Addendum No. 4

August 25, 2022

Project: San Fernando Pacoima Wash Bikeway and Pedestrian Path, Federal Project No. ATPL-5202(020) Job. No. 7615, Plan No. P-737

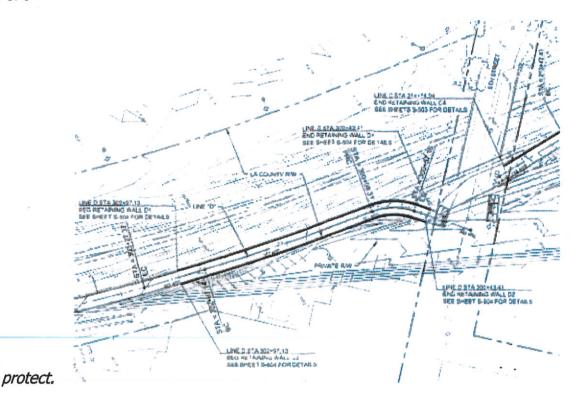
- Q23. Reference Specification Section 321216-4(2.1E): This section calls for installation of redwood header along all edges of asphalt. The drawings do not show any redwood header. If this is required please provide a drawing detail showing the redwood header as it would essential be the entire length of the pathway on both sides.

- A23. Redwood headers are required. Header to be constructed similar to the attached

detail.
